Record Summary for Board of Adjustments

Record #	Status	Opened Date
BOA-26-000003	Additional Info Required	01/15/2026

BUILDING OFFICIAL'S REPORT: Application of Chris Dillard for (1) a special exception to the fence height regulations at 10506 LAKEMERE DR. This property is more fully described as Block E/7317 Lot 1, and is zoned R-7.5(A), which limits the height of a fence in the front yard to 4-feet. The applicant proposes to construct and/or maintain an 8-foot-high fence in a required front-yard, which will require a 4-foot special exception to the fence regulations.

SITE PLAN

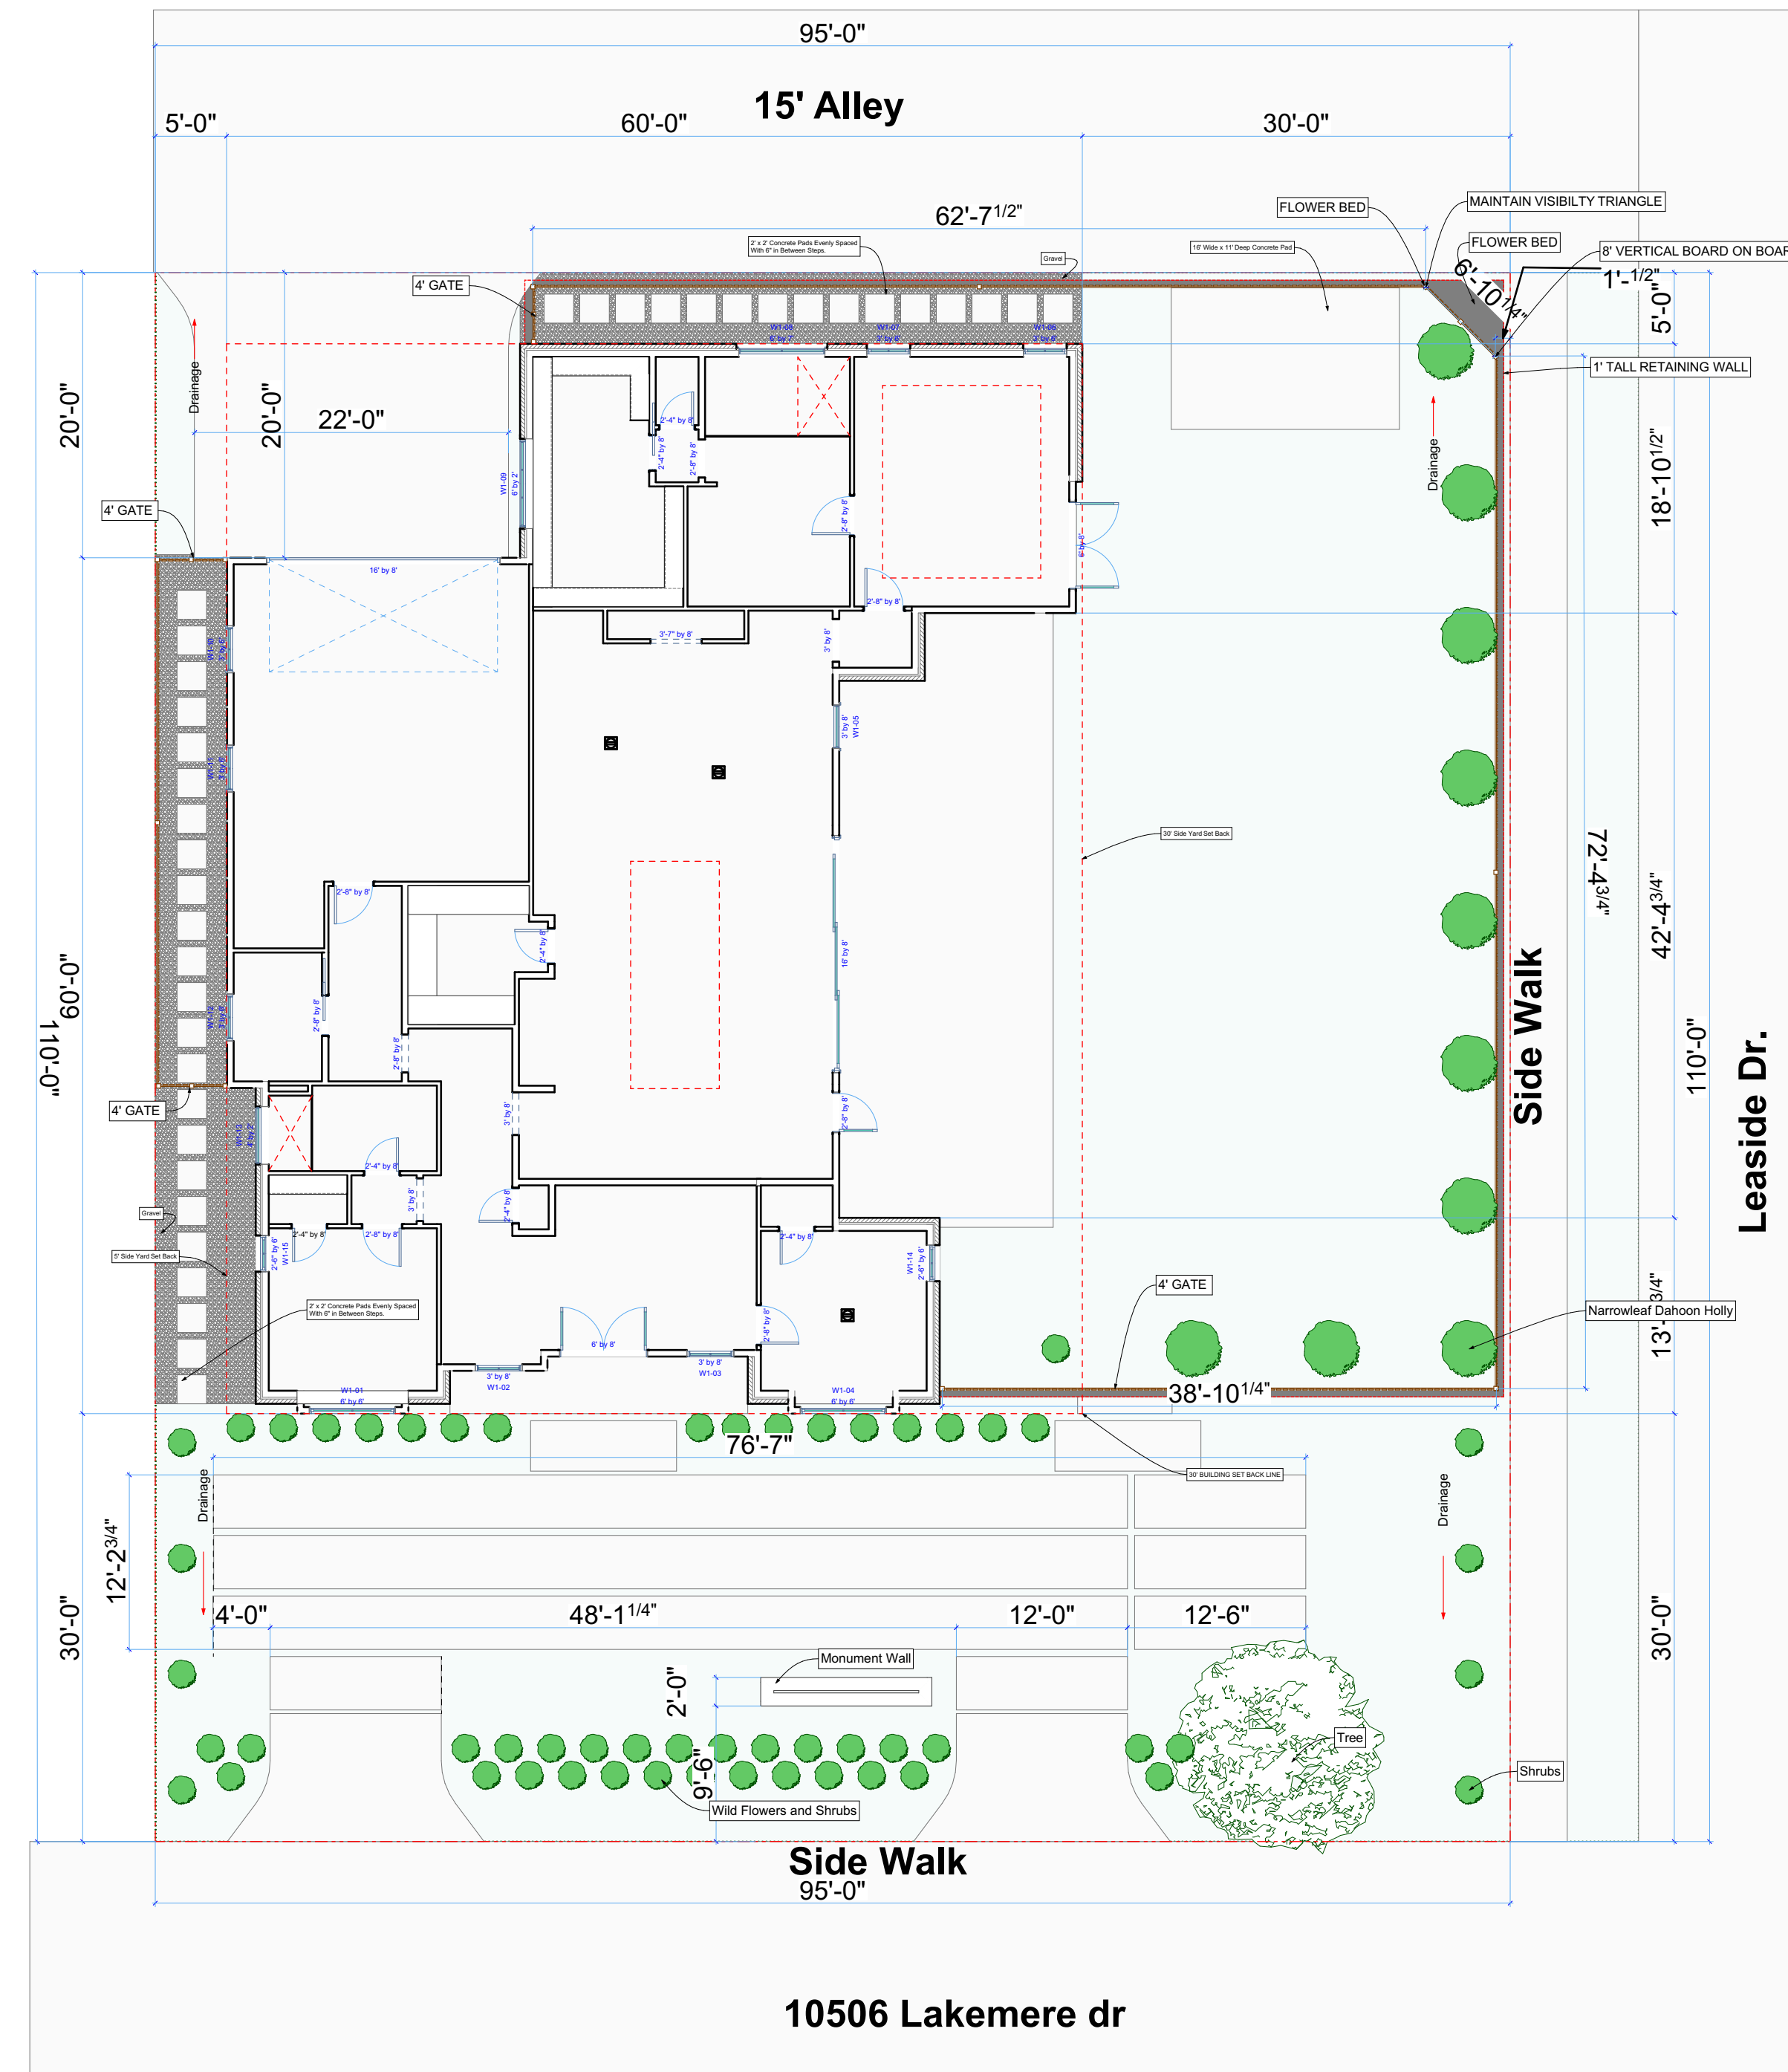
Status	Comment	Assigned Name	Status Date
Additional Info Required	<p data-bbox="241 142 570 170">Please review the following:</p> <p data-bbox="241 205 1052 289">An opacity request is required for the fence along Leaside unless 50% of the fence panels are open. Please indicate the percentage of openness on the plans (per architect).</p> <p data-bbox="241 296 1052 464">Please add 20-ft visibility triangles at the drive approaches, as well as at the alley and street corner. Additionally, include a 45-ft visibility triangle at the corner of Lakemere and Leaside. It appears there may be slight obstructions within all visibility triangles. Note that no trees or landscaping may exceed 2.5 ft to 8 ft within these areas along Lakemere.</p> <p data-bbox="241 470 1052 529">Will you be submitting, or have you already submitted, plans for new driveway approaches?</p> <p data-bbox="241 535 1052 640">Have you discussed the potential issue of parking within the front yard with Residential Review? You may want to confirm approval of the drive approach layout, as parking is not permitted within the front yard setback.</p> <p data-bbox="241 646 1052 821">Is there a permit for new construction or an addition to the existing house? There are comments on other cases indicating a pool permit was denied within the front yard. Have you decided to remove the pool? If you need to request a variance for the front yard, please note this cannot be heard prior to a replat for removal of the building line. Have you discussed this issue with Subdivision?</p> <p data-bbox="241 827 1052 911">Fence height must be measured from grade to the highest point of the fence, wall, column, or gate, and must include any retaining wall. Please update the height request accordingly.</p> <p data-bbox="241 917 1052 1001">If you have plans that do not include the house, please submit those and include the fence height measurements only. This may help avoid any hesitation from the board related to the house plans.</p> <p data-bbox="241 1037 1052 1087">Please note that additional information or items may be requested later in the process.</p>	Diana Barkume	04/01/2026
